**PENSACOLA PARTNERING TEAM
MEETING MINUTES**

Date - September 2 -3, 1998
Location - EPA, Atlanta
Team Leader- Karen Atchley
Recorder - Brian Caldwell, Ron Joyner
Gate Keeper/Timekeeper - David Grabka
Process Facilitator - Allison Dennen-Harris
Facilitator-

Re: Add +
Well - install.
OV 13
Aug. 1998

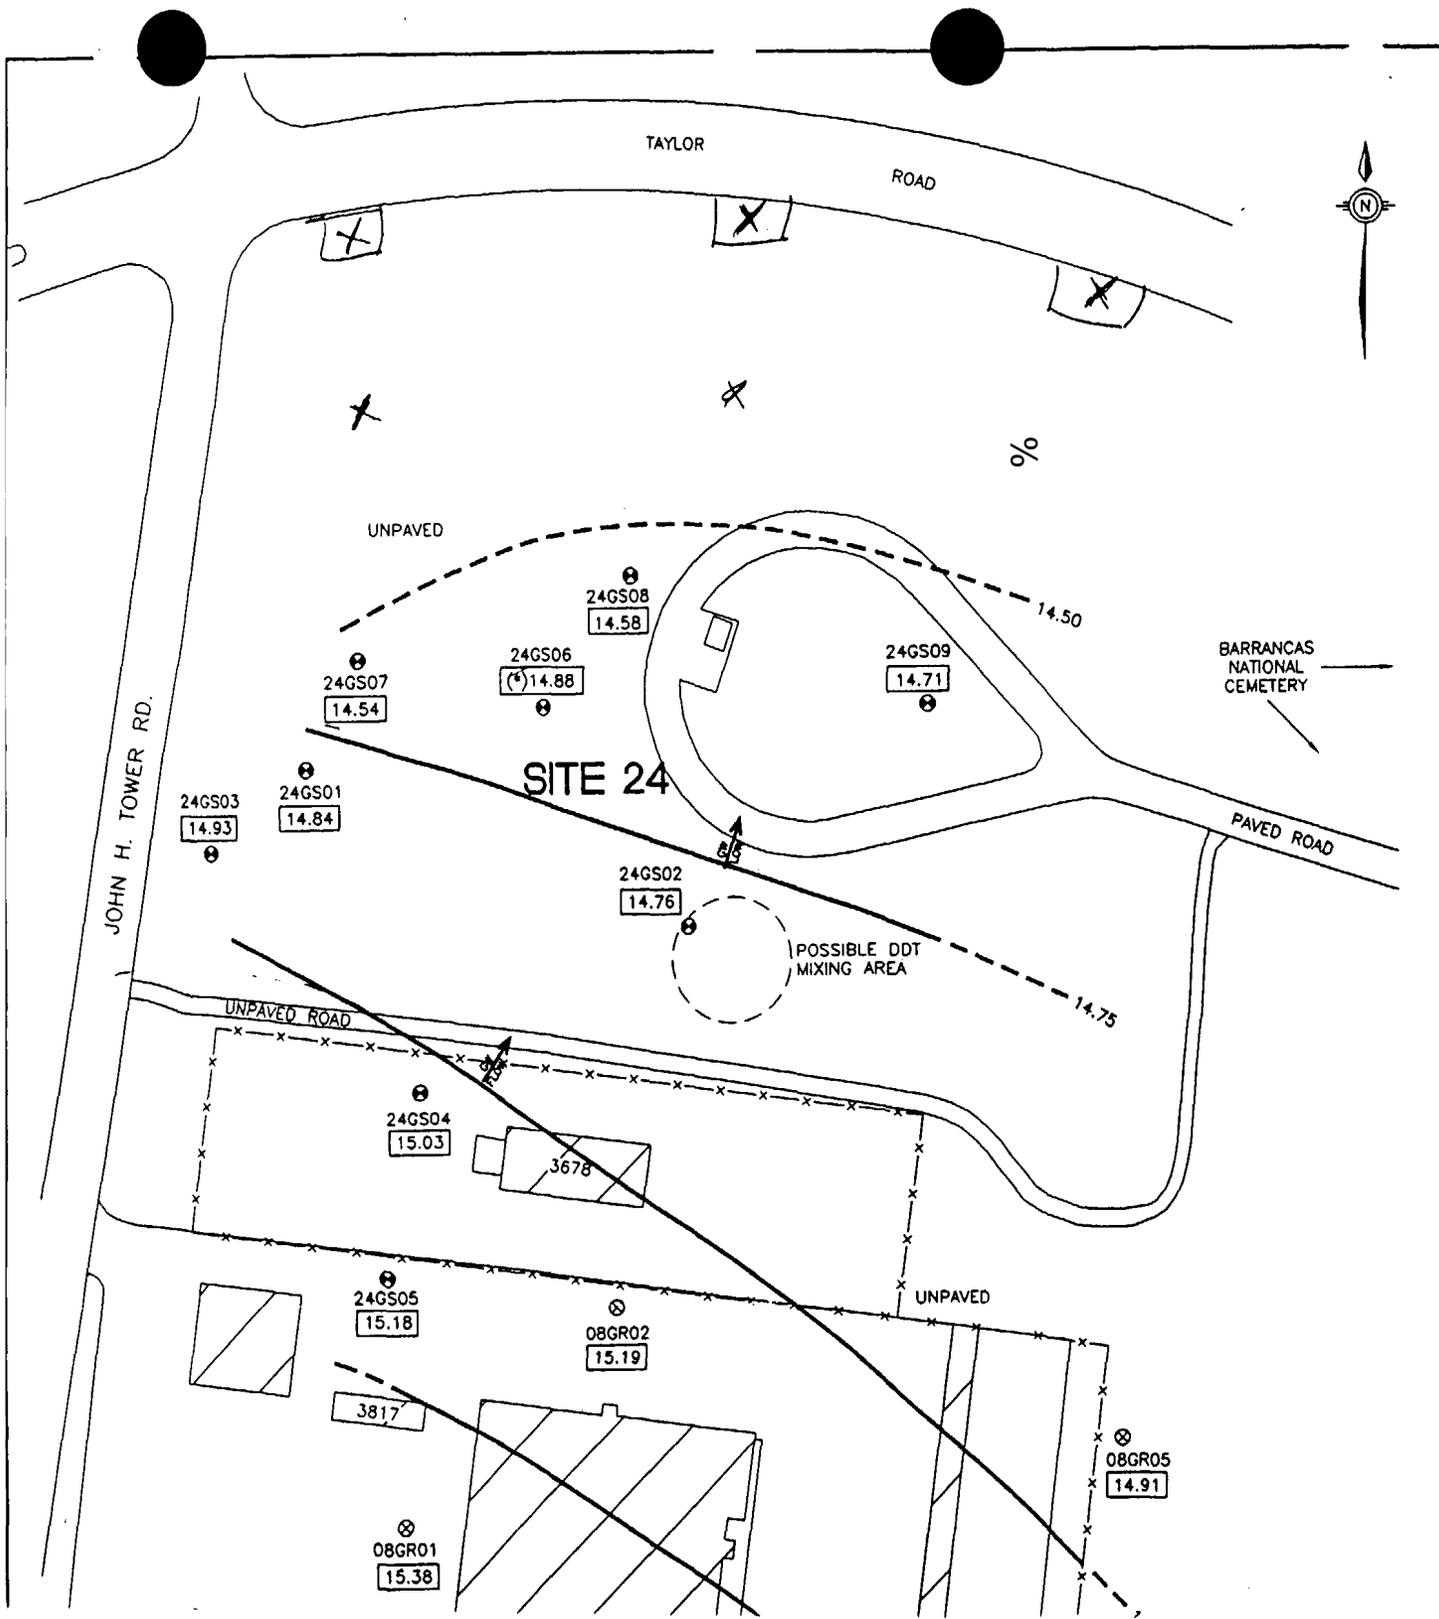
- a) Three new temporary wells are needed, and three new permanent wells are needed. The permanent wells shall be installed along Taylor Road north of the site, and spaced more or less evenly along the northern span of the site to cover the anticipated flow from the site. The temporary wells shall be installed intermediate to the new wells and the existing wells, again arranged evenly to cover a northerly flow from the site. Samples from these wells shall be sampled for the TAL.
- b) During drilling of the new wells, both surface and subsurface soil shall be sampled (consistent with past sampling intervals) and analyzed for the full TAL/TCL (the purpose of these is to confirm the limited extent of heptachlor epoxide - heptachlor epoxide was detected at a single sample location at 71 ppm, but with a PRG of 70 ppm the Team had previously decided that further delineation was not required).

- c) During well sampling, wells GS01, GS07, GS08, and **GS09** shall be resampled for the TAL.
- d) If wells GS09 or GS07/01 have been destroyed or damaged, then replace them for the resampling event.
